**BOULDER COUNTY PLANNING COMMISSION
PUBLIC HEARING**

STAFF RECOMMENDATION

Docket SU-21-0013: Butte Blacksmith LLC Repair Garage

Request: Special Use Review to allow for two principal uses (Vehicle Sales/Rental Lot and General Industrial) on the parcel, as well as 2,390-cubic-yards of non-foundational grading, deconstruction of a 2,786-square-foot repair garage, 530-square-foot mobile home, 64-square-foot shed, and 40-square-foot shed, construction of a 9,344-square-foot repair garage, and conversion of an existing 904-square-foot residence to an office use associated with the repair garage on a 1.76-acre parcel.

Figure 4: Proposed site plan, with new structure indicated in dark gray.

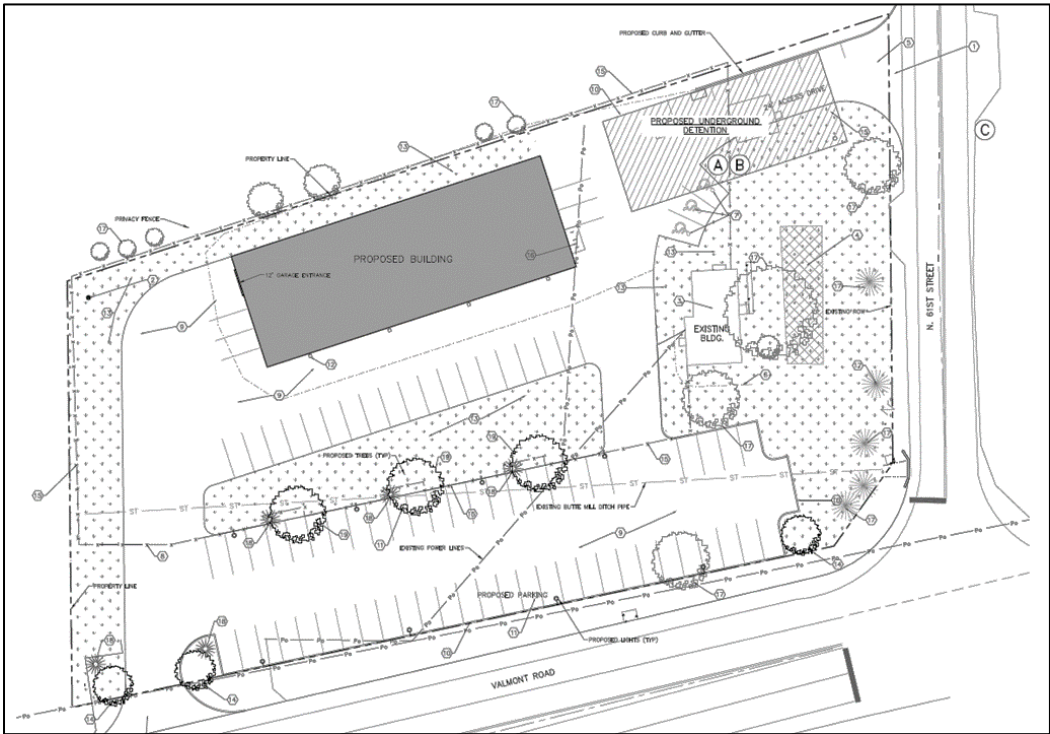
The new proposed garage structure is located in the northern portion of the subject property (see Figure 4 below). In the General Industrial district, structures must be outside of the following required setbacks: front yard setback of 60 feet from the centerline of the right-of-way; side yard setback of zero (0) or 12 feet; and rear yard setback of 20 feet. Per Article 18-175A of the Code, for unsubdivided parcels located on a corner, all street frontages shall be subject to front yard setbacks. Since the subject parcel is a corner lot, both the southern and eastern portions of the parcels are subject to the front yard setback of 60 feet from the centerline of the right-of-way; staff finds the proposed structure meets this front yard setback. Article 18-175A.B also defines a rear lot line as “The boundary line opposite and parallel to the front line. In the event no lot line is opposite and parallel to the front lot line, there shall be no rear.” Staff has determined that the northern property line is opposite but **not** parallel to the front lot line along Valmont Road; as such, the northern property line is subject to the side yard setback of zero (0) or 12 feet. Staff finds the proposed structure meets this side yard setback. The western lot line, however, is both opposite and parallel to the front lot line along N. 61st Street and is subject to the rear yard setback of 20 feet. Staff finds the proposed structure meets this rear yard setback.

Figure 5: Proposed new structure (indicated in dark gray); the 110-foot supplemental setbacks (indicated in light gray); and the 50-foot ditch setback (indicated in dark blue).

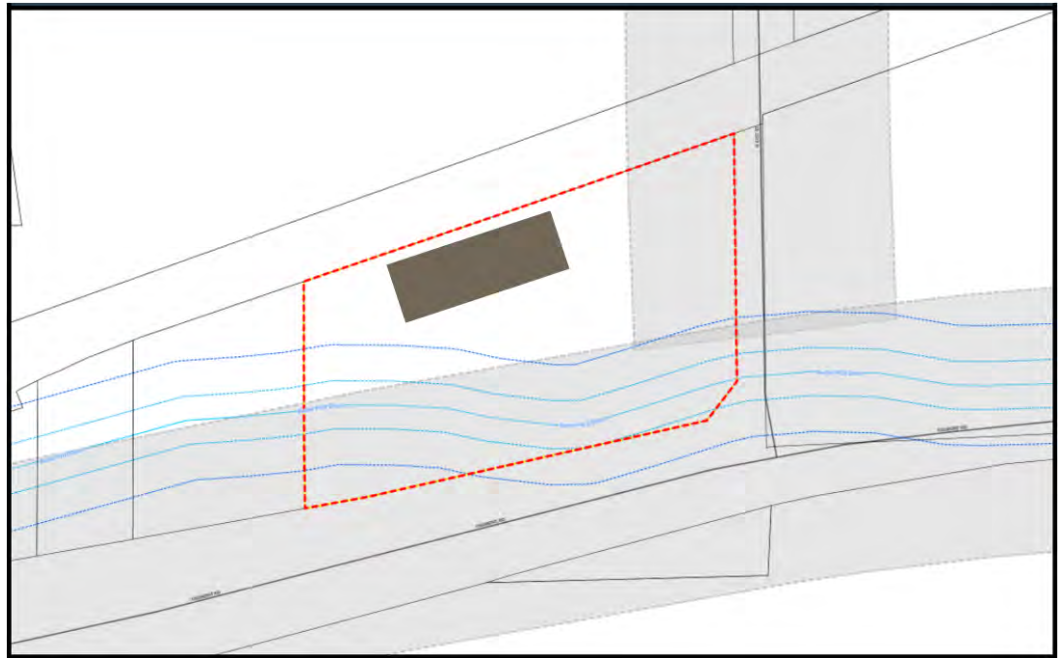
In addition to the standard zoning district setbacks, the subject parcel is also subject to the supplemental setbacks discussed above (110 feet from the centerlines of Valmont Road and N. 61st Street), as well as a 50-foot ditch setback for the Butte Mill Ditch. The proposed new structure would be located outside of the supplemental setbacks and the ditch setback (see Figure 5 below).

Figure 6: The front (south) and rear (north) elevations of the proposed new structure.

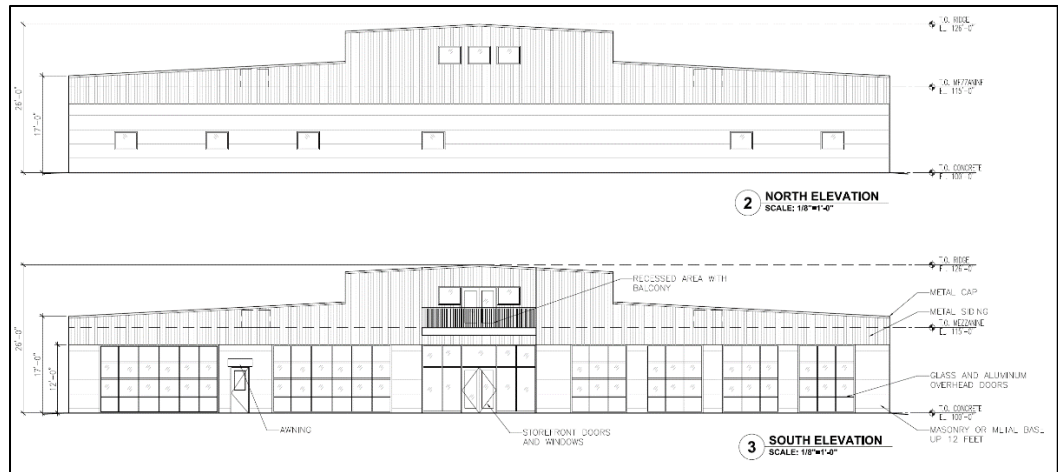
As discussed above, the applicant has proposed to construct a 9,344-square-foot repair garage; the structure would have a 7,276-square-foot first floor and a 2,068-square-foot second floor. The second story portion of the structure is a little less than 1/3 of the total length of the structure and is located in the middle (see Figure 6 below). The proposed maximum height of the structure would be 26 feet above existing grade. Most of the front façade of the structure would be 12-foot-tall overhead doors. The applicant has proposed that these overhead doors would be a combination of glass and aluminum, made up of four rows of 2-foot-tall panels; the applicant has stated that they plan to have the top three (3) rows be glass and the bottom row aluminum. In the middle of the first floor front elevation, there would be a set of double doors, with two (2) storefront windows on either side and fixed transom windows above the windows and doors. The applicant has proposed a recessed balcony on the second story, above the entrance. This balcony would be accessed via a set of double doors from the second story; there would one (1) small window to either side of the balcony doors. There are a total of six (6) small windows on the first floor of the rear elevation, and three (3) on the second floor. The eastern elevation would have one (1) overhead door, one (1) pedestrian door, and one (1) small window. The western elevation would have two (2) pedestrian doors and one (1) small window. The proposed exterior would be metal or masonry on the first floor and metal on the second floor; it would be white and red in color.

6. The new garage structure shall be limited to one story, not to exceed 17 feet above existing grade at the eastern and western edges and 20 feet above existing grade in the center of the structure. Plans submitted for permitting must be revised to demonstrate compliance with these height limits.

Figure 7: Approximate roofline (indicated in red) and massing of proposed structure (indicated in blue) based on recommended condition of approval superimposed on proposed elevation.

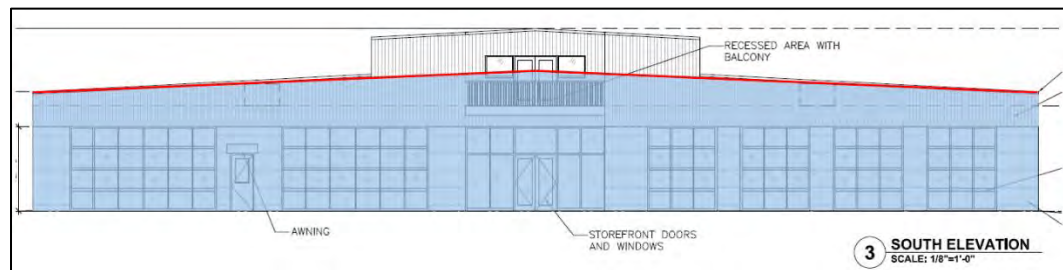
Based on analysis of other structures in the area, staff have determined that the new garage structure as proposed would not be compatible with the surrounding area. Staff have determined that the structure would have significant visual impacts due to the structure's bulk and massing. While there are some taller structures in the area, the majority of structures are only one story and are generally much smaller. As such, staff recommends as a condition of approval that the structure be limited to one story, not to exceed 17 feet above grade at the eastern and western edges and 20 feet above existing grade in the center of the structure. Limiting the maximum height to 20 feet above grade would significantly decrease the visual bulk and massing of the structure (see Figure 7 below).

Figure 8: Recommended glazing limits for overhead doors, with glass panels indicated in blue and solid panels indicated in gray. The recommend windows and transom panels to be removed indicated in red.

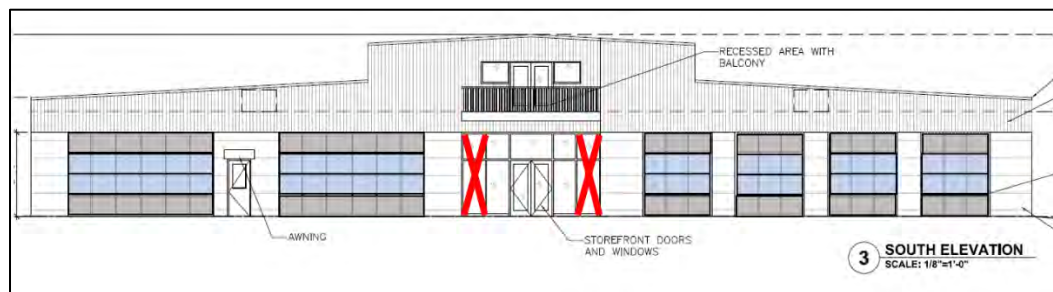
As discussed above, per the application materials submitted, the proposed structure would have significant amount of glazing (glass) due to the proposed overhead doors and customer entrance. Significant amounts of glazing, especially on southern elevations, can result in reflected sun-glare on to public rights-of-way and other properties. Excessive glazing can also result in increased impacts from indoor lighting at night. As such, staff recommends as a condition of approval that the overall glazing be reduced by requiring the overhead doors to be no more than 50% glazing and removal of the outer windows and transom panels on the doorway into the shop reception area (see Figure 8 below).

Figure 9: April 19, 2023, site with staff recommended modifications. The proposed privacy fence is indicated in blue; the staff recommended landscaped buffer and parking lot islands indicated in green rectangles; and the staff recommended tree screening placement in green stars.

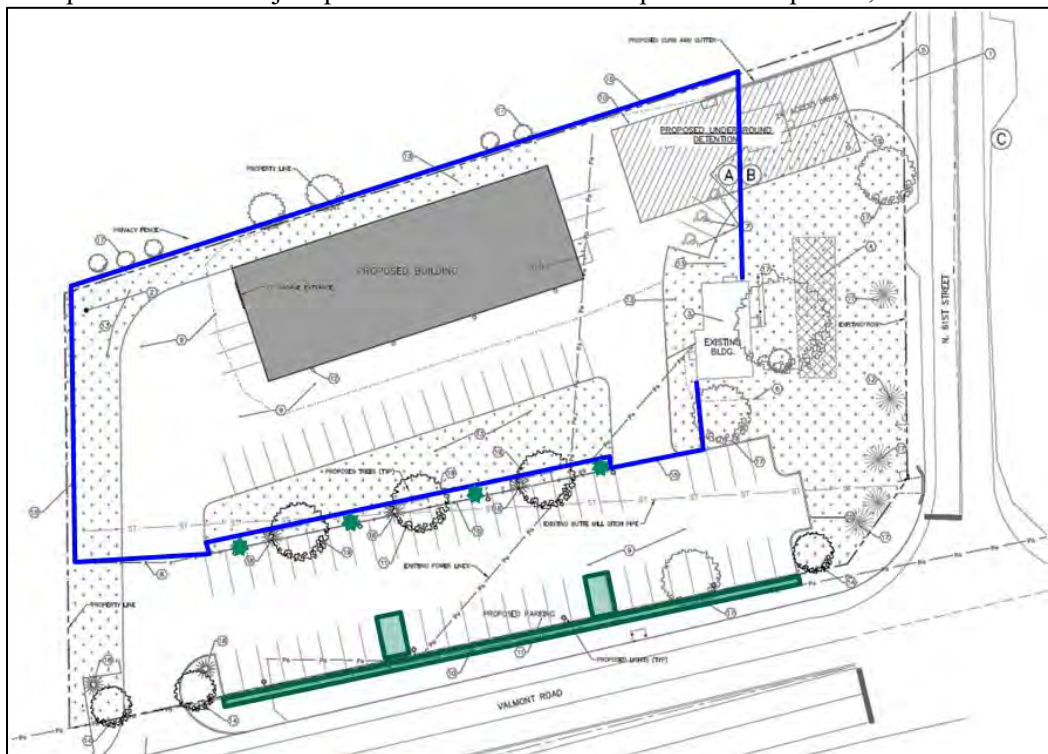
The subject property is also very visible from N. 61st Street. The proposed new structure is set well back from the N. 61st Street ROW and is screened by a number of existing trees. To ensure that the proposed uses are visually screened from N. 61st Street, staff recommends as a condition of approval that the applicant preserve and maintain the existing trees on the eastern portion of the subject parcel as shown in the site plan dated April 19, 2023.

The April 19, 2023, site plan also shows a proposed privacy fence running along the southern edge of the interior landscaped area in the middle of the site. The fence as proposed will help to shield a significant portion of the parking area from the public right-of-way. However, the placement so the fence as proposed would result in the six (6) proposed trees in the

landscaped area being reduced to three (3) clumps, which would do little to provide landscaped screening. As such, staff recommends as a condition of approval that the applicant install a minimum of seven (7) trees along the southern edge of the interior landscaped area, spaced as evenly as possible; additionally, staff recommends as a condition of approval that the proposed privacy fence be located north of the trees (see Figure 9 above).

10. Plans submitted for permitting must include a landscaped buffer, at least six (6) to eight (8) feet wide, between the proposed parking area and the public right-of-way along Valmont Road.

12. Plans submitted for permitting must include a minimum of two (2) landscaped “islands,” generally evenly spaced, in the southern most row of parking spots.

Preliminary Site Plan (Outdated) - May 31, 2021

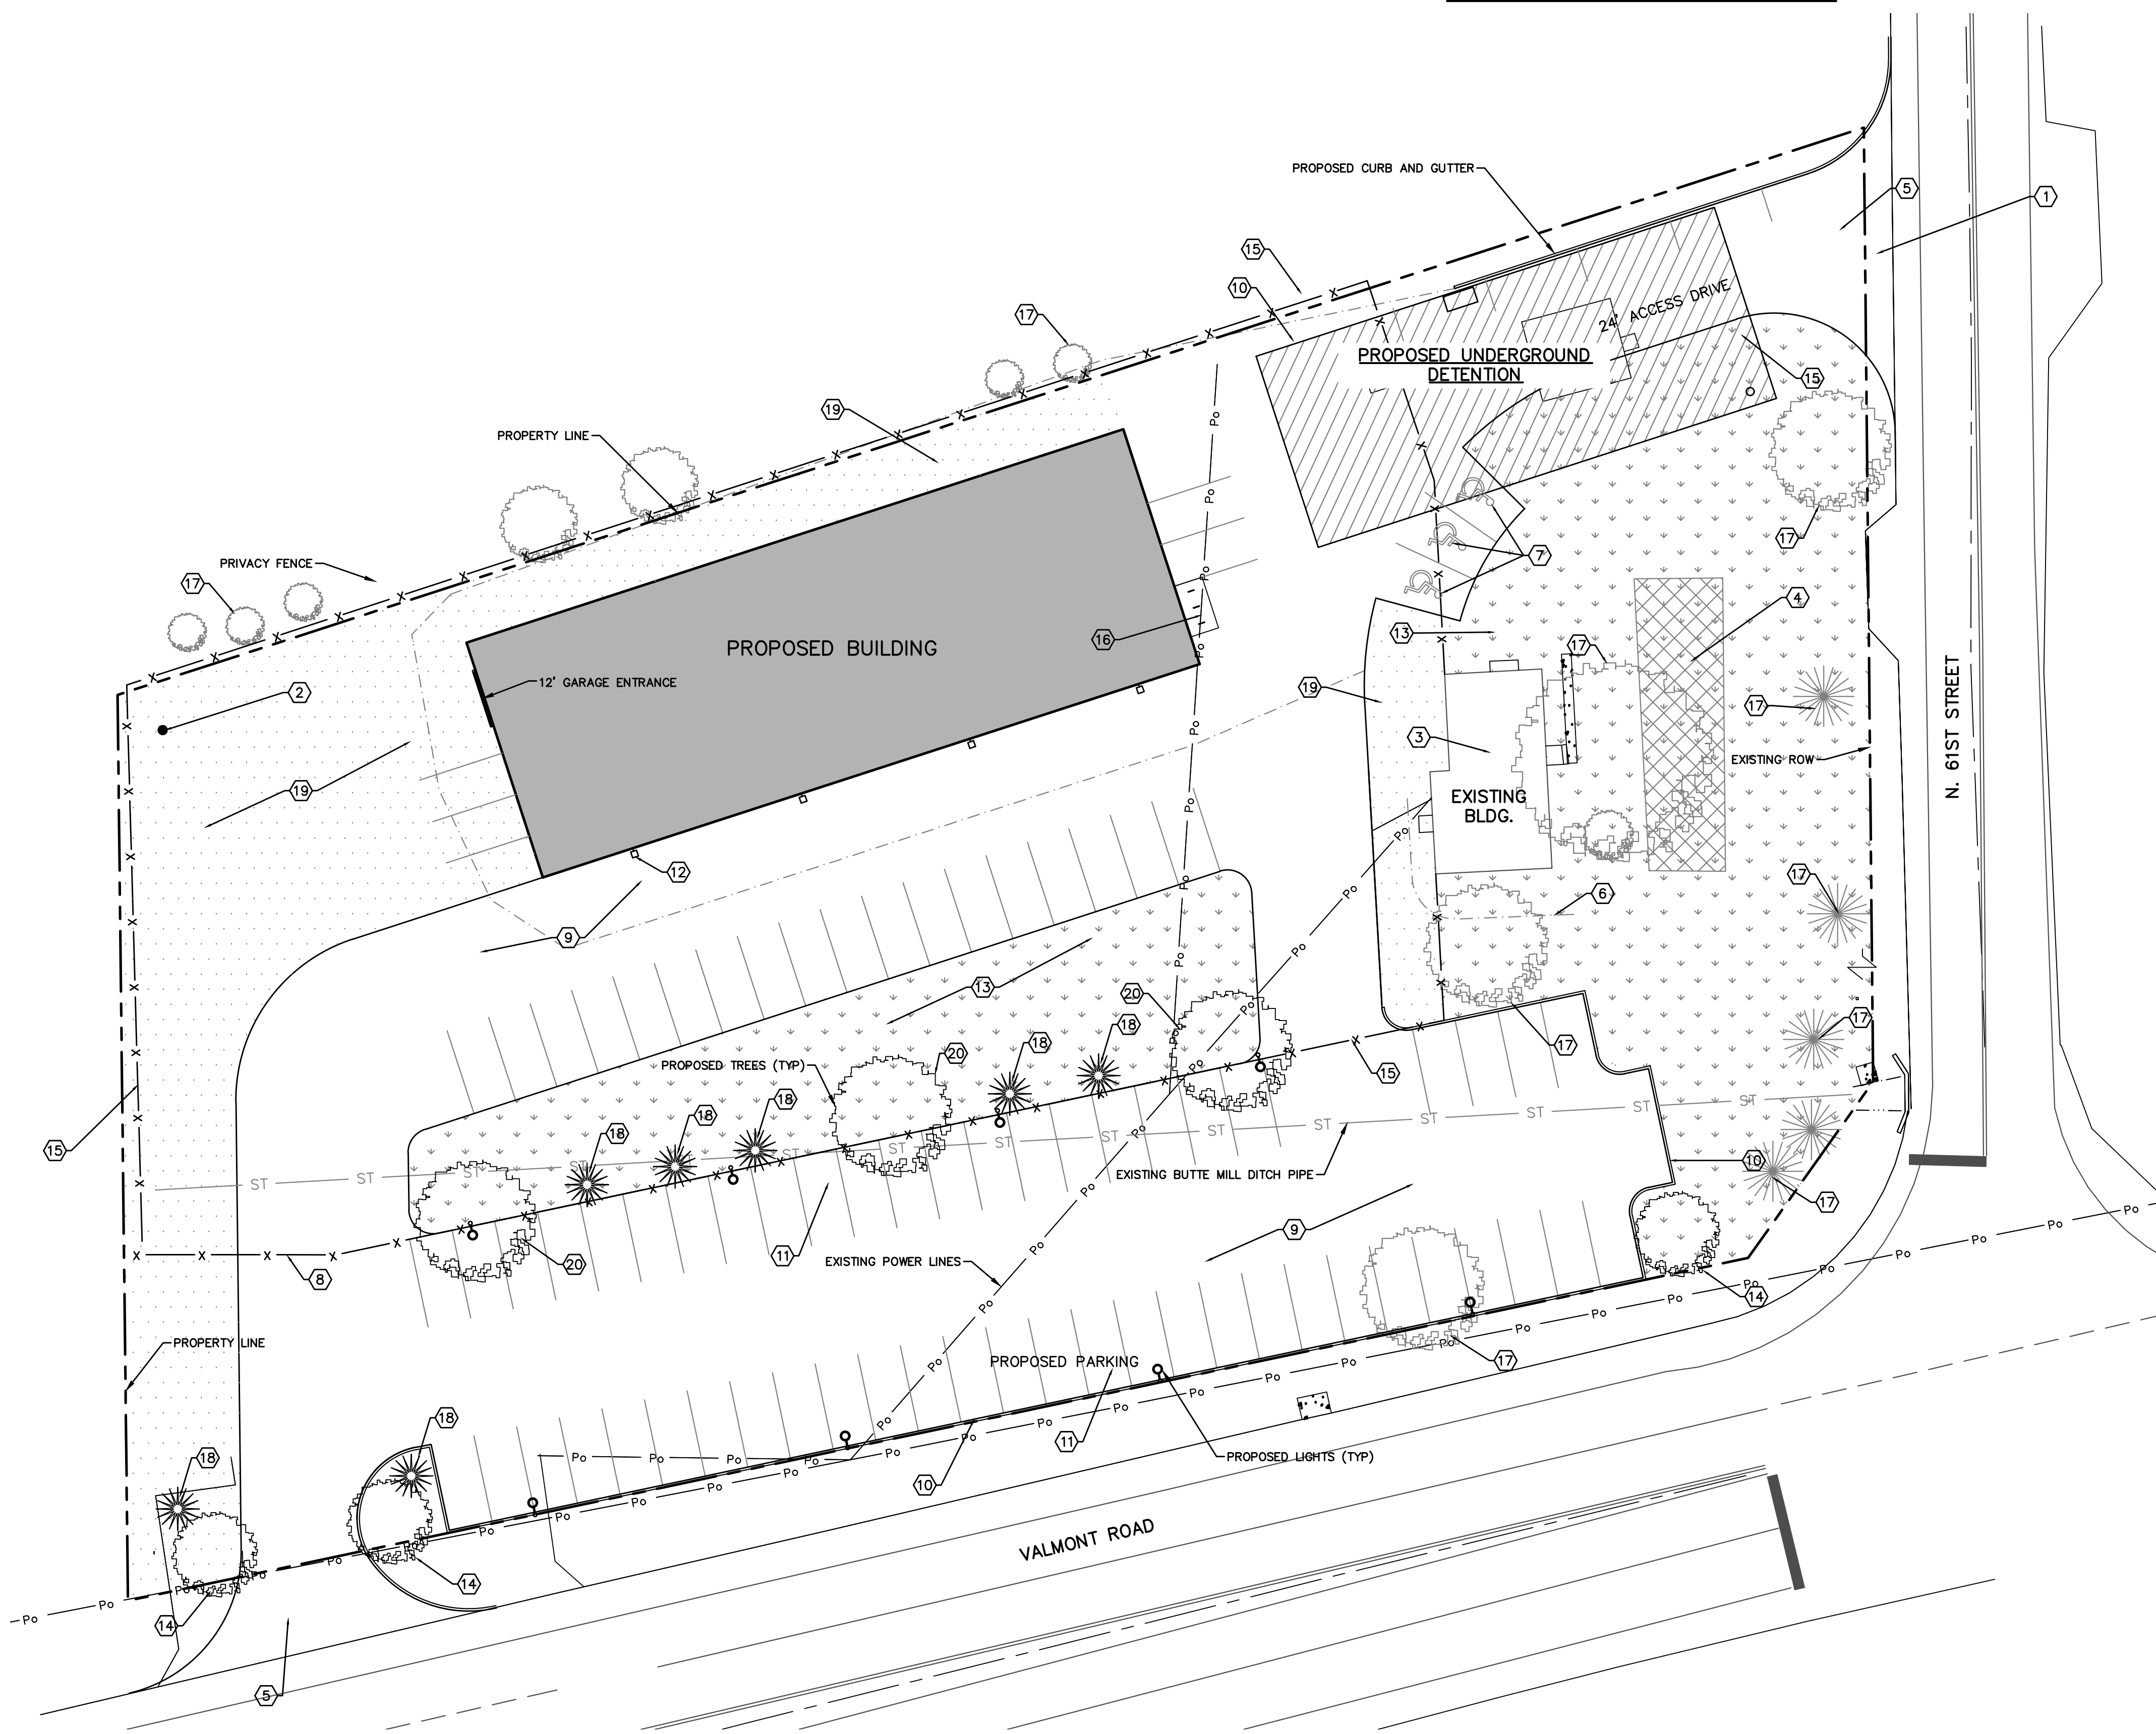
Preliminary Site Plan, Sheet 1 of 2 – The privacy fence does not traverse the entire northern boundary; it should.
